MONTGOMERY COUNTY HISTORIC PRESERVATION COMMISSION
STAFF REPORT

Address:	7110 Sycamore Ave., Takoma Park	Meeting Date:	5/24/2017
Resource:	Contributing Resource (Takoma Park Historic District)	Report Date:	5/17/2017
Applicant:	Joan Marsh (Owen Philbin, Agent)	Public Notice:	5/10/2017
Review:	HAWP	Tax Credit:	Partial
Case Number:	37/03-17II	Staff:	Michael Kyne
PROPOSAL:	Roof reconfiguration, non-historic window replacement, and other alterations

Previous Proposal (April 19, 2017)

EXISTING FRONT (EAST) ELEVATION

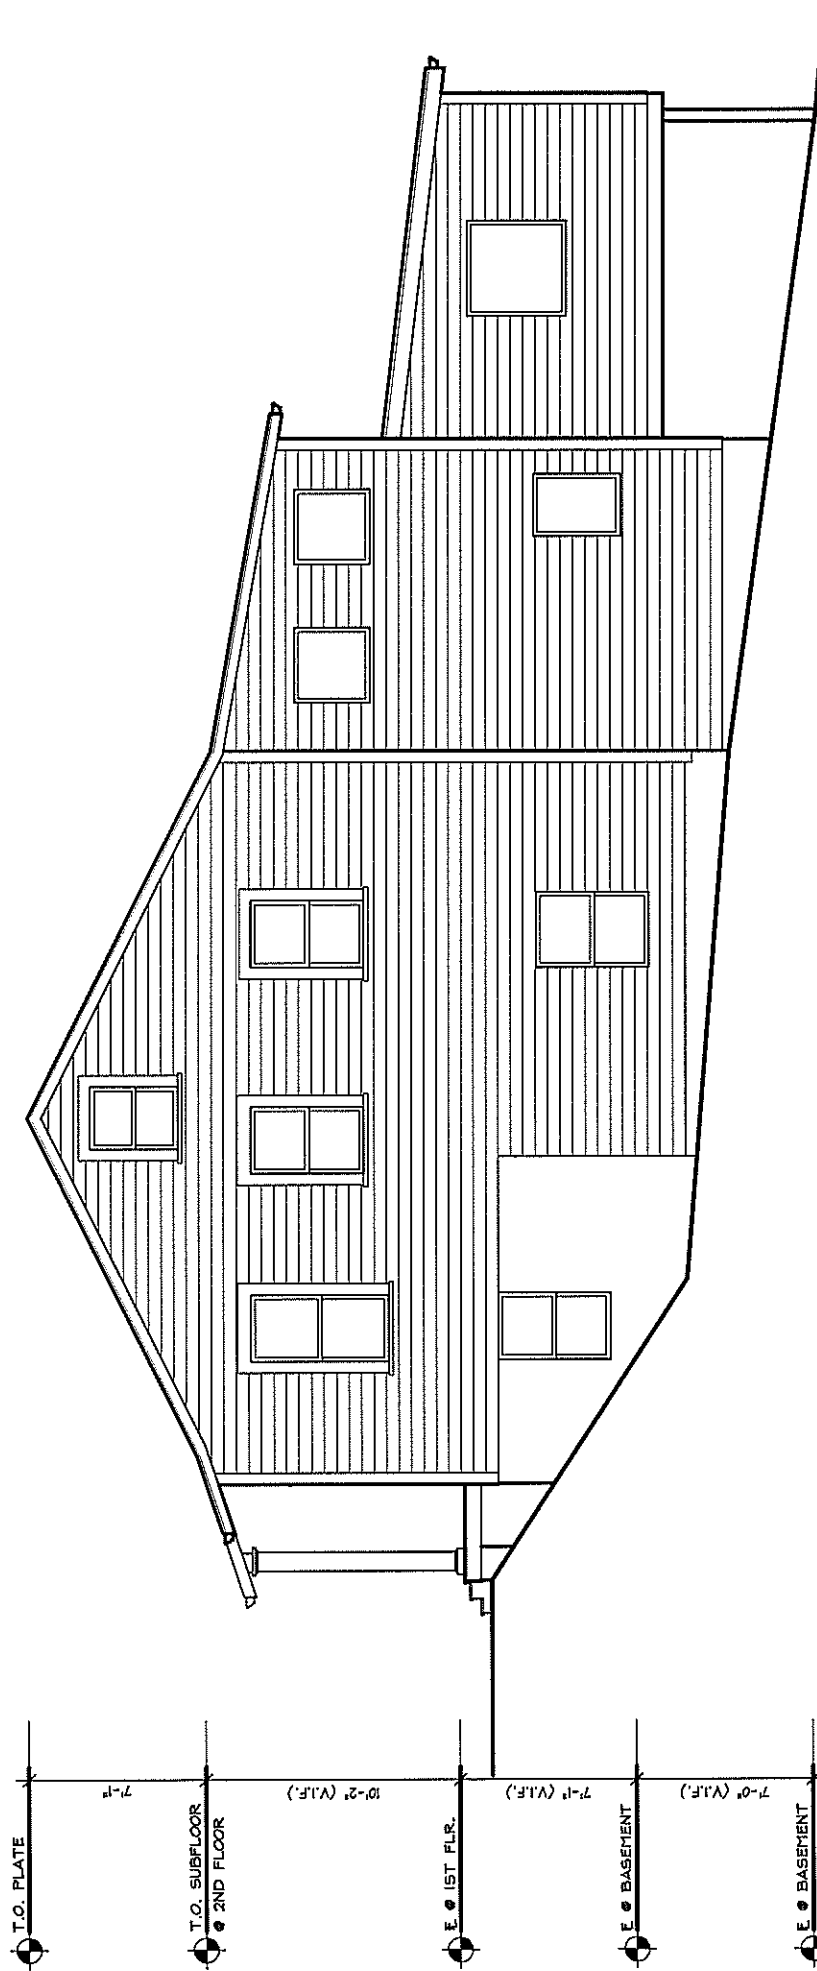
18 MR. KIRWAN: Well, it is, but it's not nearly as
19 dramatic as the front elevation and the side -- existing
20 elevations are drawn. So at the most it breaks off from the
21 gutter board a few inches. But, it shows as a much
22 pronounced shed in the existing drawing. So, I think in the
23 proposed front facades, we're getting something closer to
24 what actually exists, than what we're seeing in the
25 existing.

3 MR. KIRWAN: So I think there's some drafting
4 issues on the drawings that we need to have the applicant
5 address. Okay. Any other questions for Staff? If not,
6 invite the applicant please come forward. You're welcome to
7 provide any testimony, or just take our questions. Whatever
8 you prefer. And before you speak, just state your name for
9 the record.

22 MR. PHILBIN: I mean, my existing drawing must be
23 wrong.

EXISTING FRONT (EAST) ELEVATION

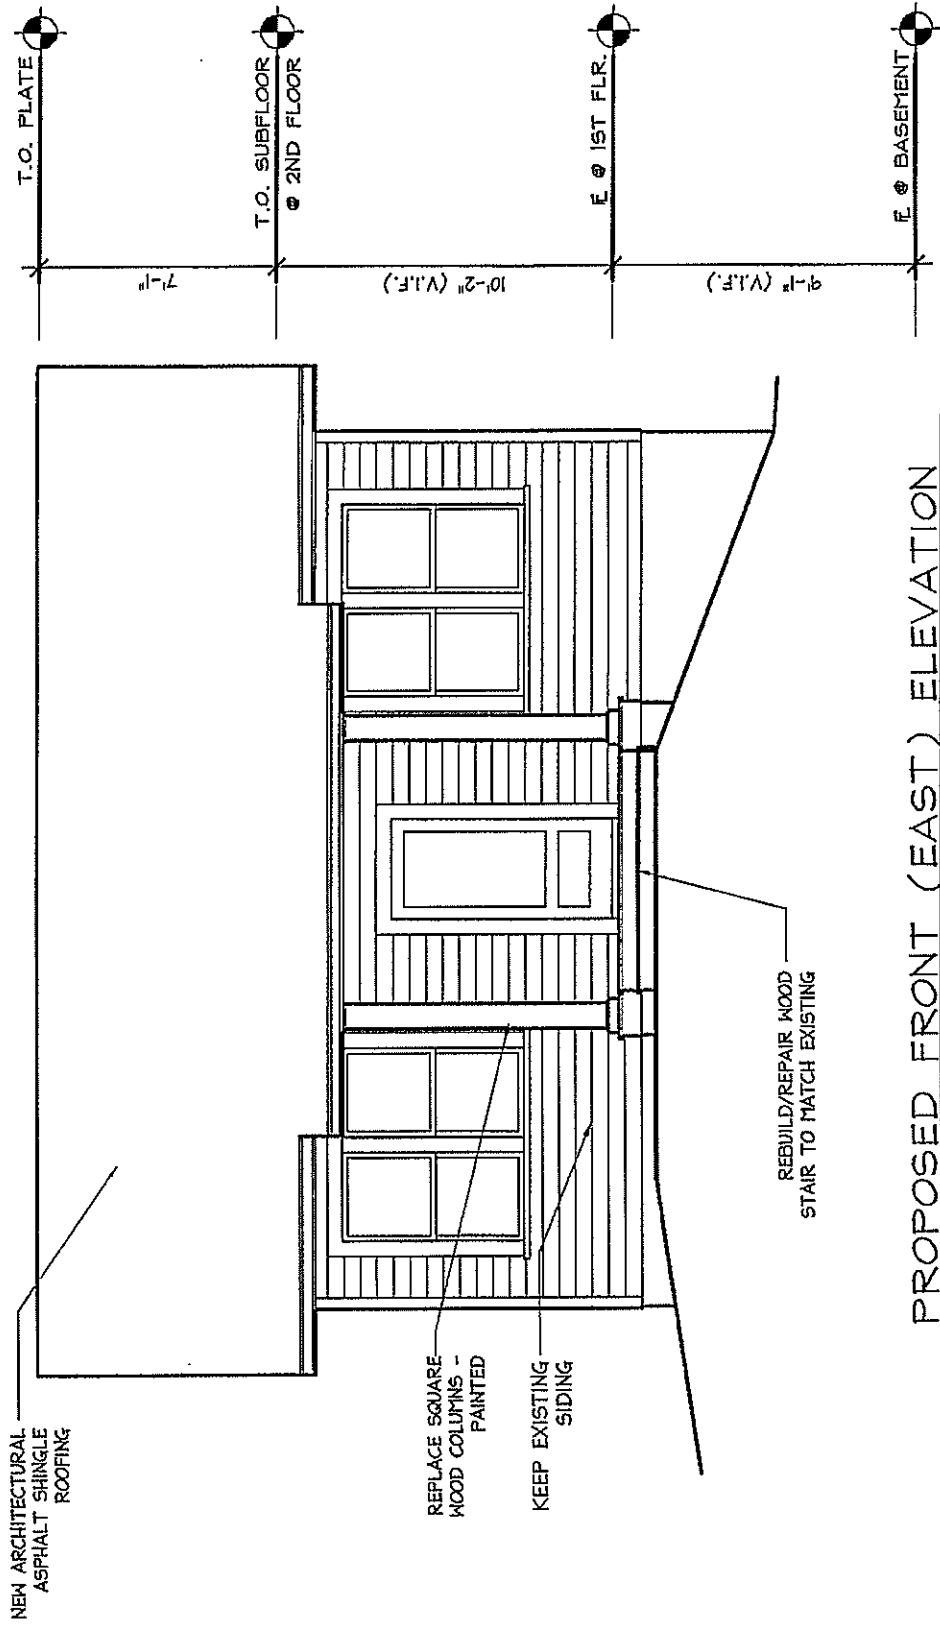
11 MR. KIRWAN: There's a slight angle shot that you
12 have in here of the front facade, it's in the Staff packet,
13 maybe you don't have it up on the slide. It's not as
14 dramatic as -- if you pull up the existing front facade
15 drawing --

PROPOSED FRONT (EAST) ELEVATION

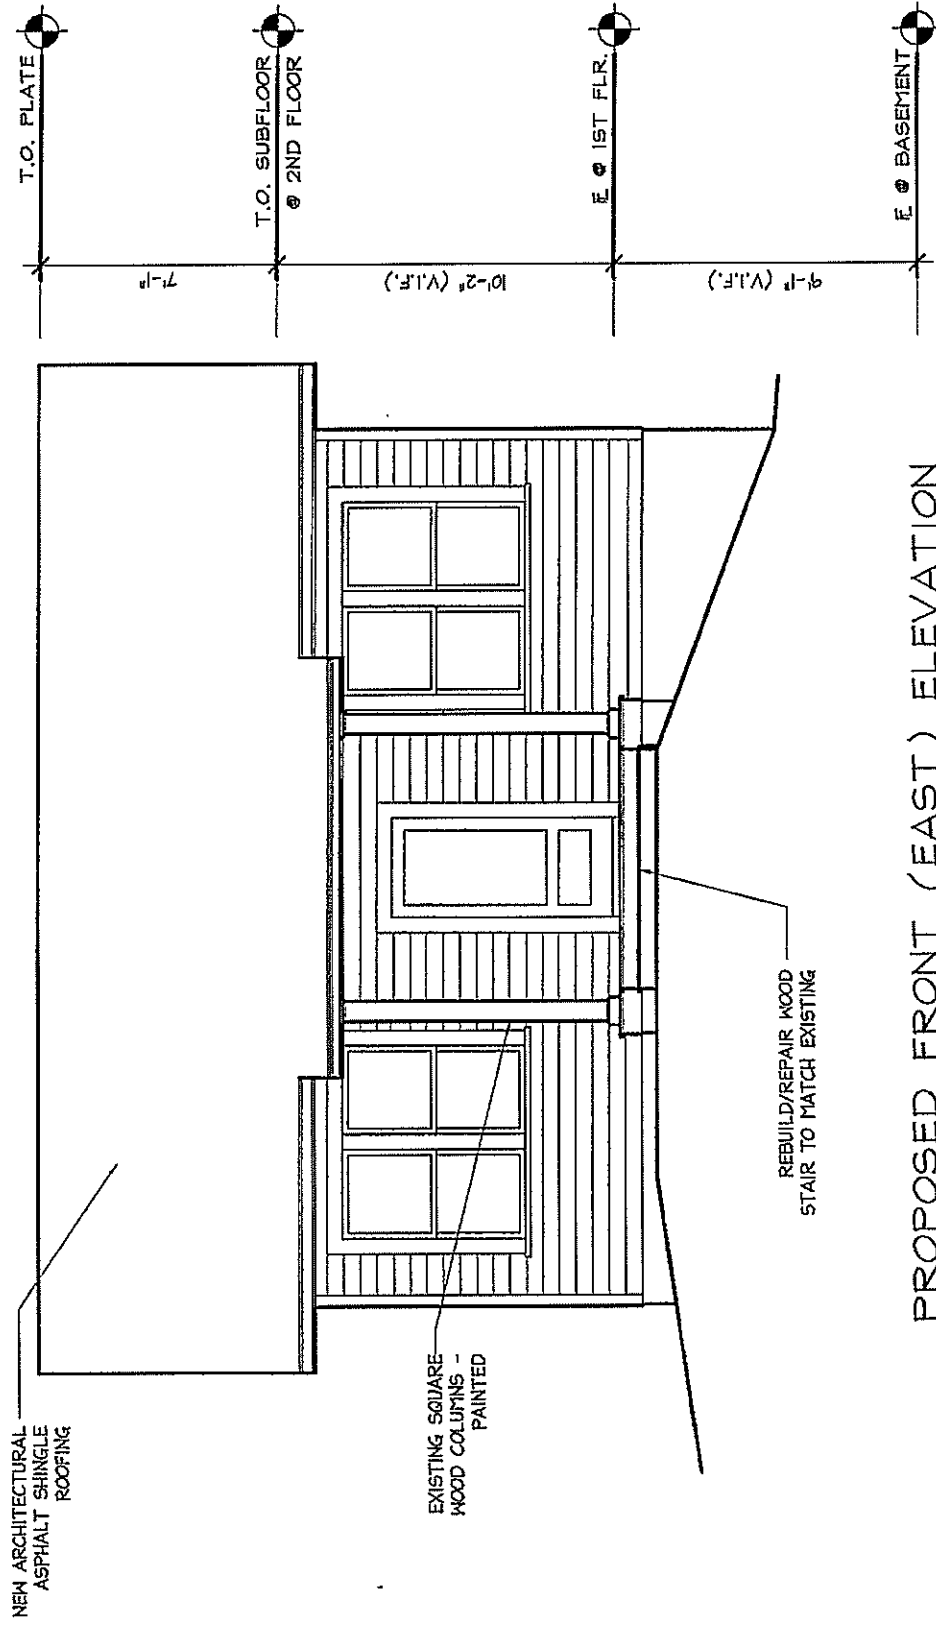
10 And the front porch. Again, as I showed you in
11 the existing of the two proposals, the applicant proposes to
12 rebuild the central front porch. However, in Option 1, the
13 front porch is depicted as being wider. This might be an
14 error in the drawing. Maybe the intention is to have it
15 wider in both Option 1 and 2, or maybe it's not to have it
16 be wider at all. But maybe we can address that with the
17 applicant and get some feedback. And, Staff would suggest
18 that the central front porch should be rebuilt the same
19 approximate dimensions and design as the existing since we
20 do have documentation that it is original to the house, and
21 it's highly visible at the front. And, I ask for your
22 guidance on this matter.

1 it looks like from existing to proposed. And, we're
2 wondering why you're doing that? You're making the roof
3 angle shallower, at least on your drawings, that's the way
4 it reads. So, if you look at -- why don't you just flip
5 back and forth between these two, Michael and you'll that
6 window, the gable end window is much closer to the ridge and
7 dimensions say 8 foot 1 on the existing drawing, and it says
8 7 foot 1 on the proposed drawings. Is there a reason to --

7 MR. KIRWAN: Okay. Well, this is saying to the
8 top of the top of the ridge, so, okay. Because what that
9 drawing does is it gets us closer to the geometry that's
10 needed at the front porch to have it look like what's in the
11 photographs. So, I think you need to go back and verify the
12 accuracy of your drawings, and when we see an existing
13 drawing and a proposed drawing, there shouldn't be any
14 changes that you're not proposing to do in other words.
15 Because it confuses us, and it gets us fixated on something
16 that's really not, may not be an issue. So we were
17 concerned coming down here that you had made a complete
18 change to the historic roofline.

PROPOSED REAR (WEST) ELEVATION

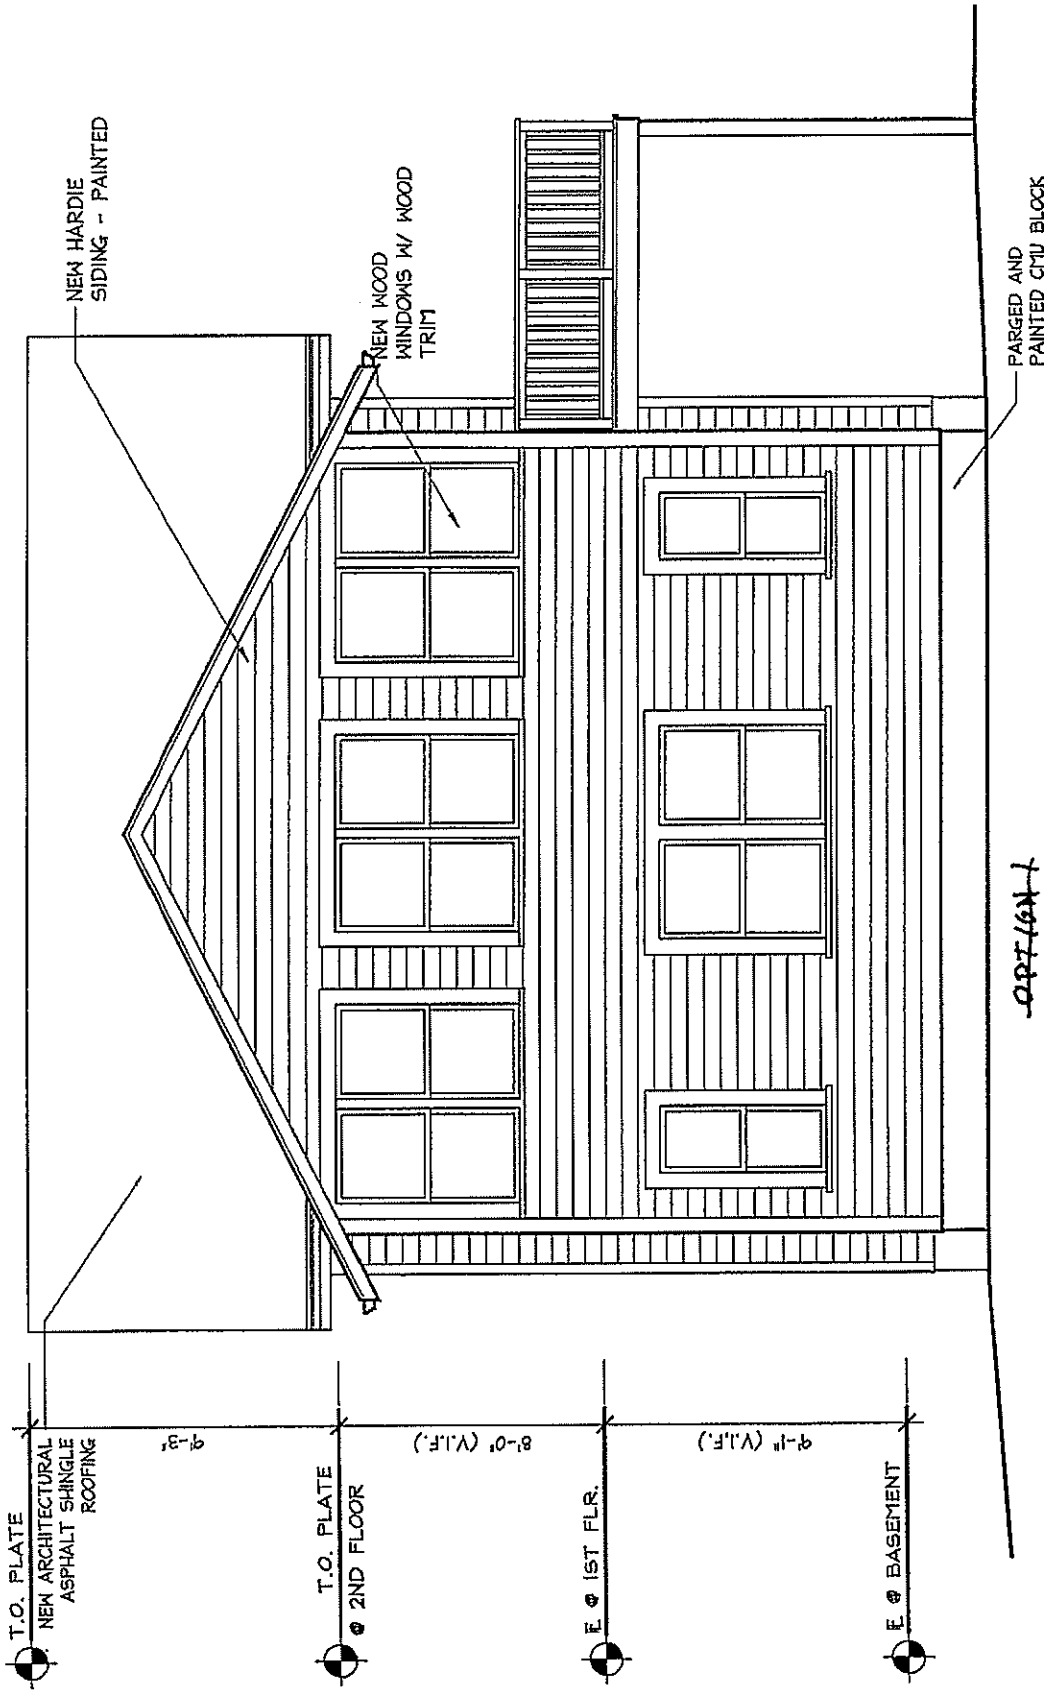
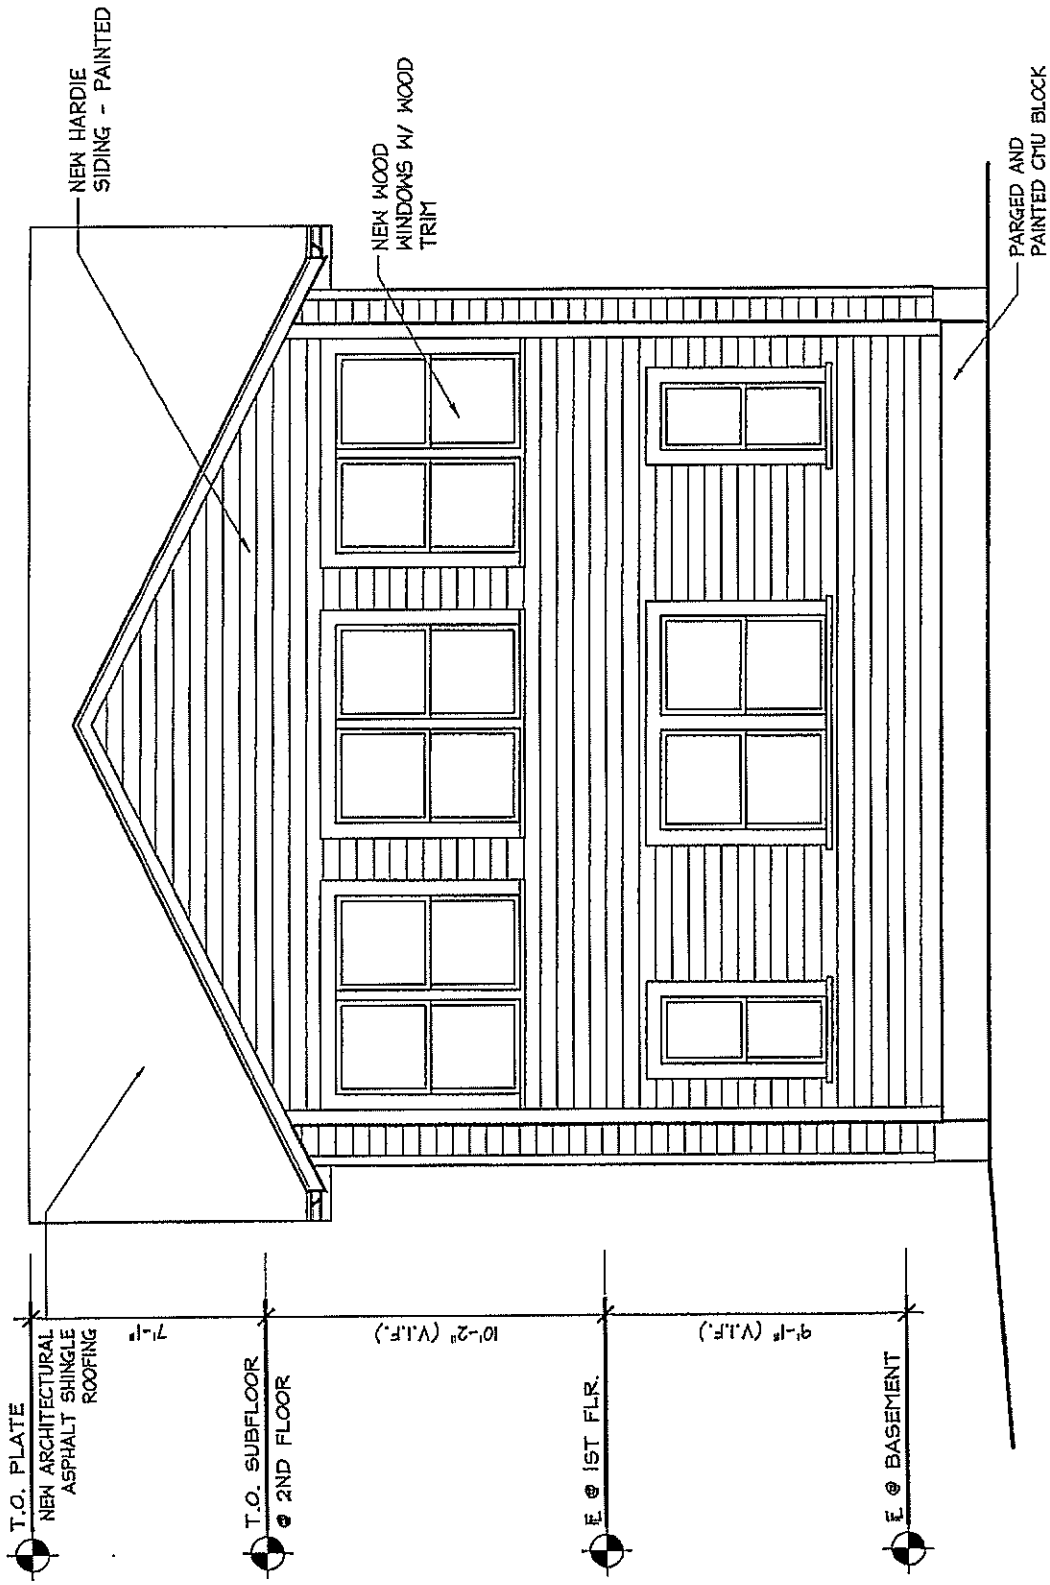
8 I think if we just jump right to the question of
9 Option 1 versus Option 2, I think I am in preference for
10 Option 1. I don't think the applied rake board really helps
11 me be more comfortable with the rear addition. I'm
12 comfortable with it as it's proposed. I have already
13 pointed out sort of in the questions that I think there
14 needs to be some order brought to the windows on the sides
15 of the -- both the north and the south side of the addition.
16 The stacking of windows, as I mentioned, like we see on the
17 addition, and like we see on the proposed rear elevation of
18 the house, that would be very helpful.

1 helpful for us to see floor plans ultimately. I think in
2 most cases we would prefer to see new additions like decks,
3 and particularly decks off of additions be towards the rear
4 of the house. It seems to be a deep lot. And since there
5 is no attempt to have a stair come down from the deck to
6 grade, the deck's just going to be up there in the air, so
7 it seems like, you know, without a plan to look at, it seem
8 like the deck could very easily be on the rear of the house,
9 and that way, not very visible from the street, which I
10 think would be a preferred location for the deck.

2 MR. KIRWAN: Okay. So I think we can bring this
3 to a conclusion. I think you've heard broad level support
4 for what you presented. I think there's just a lot of --
5 some details in the drafting that we need to clean up, and
6 we need to see floor plans when you come back. I think
7 you've heard from a few Commissioners that they might be
8 okay with the side deck. The floor plans will help. And
9 that might sway the others of us who maybe aren't quite
10 there yet. But, I think at least exploring that as an
11 option, an optional deck on the back versus the side, would
12 be helpful for us to see.

6 MR. PHILBIN: I want to get through this as
7 smoothly as possible. I am moving the deck to the back.
8 But as I do that, then I'm going to have to change the
9 windows in the back.
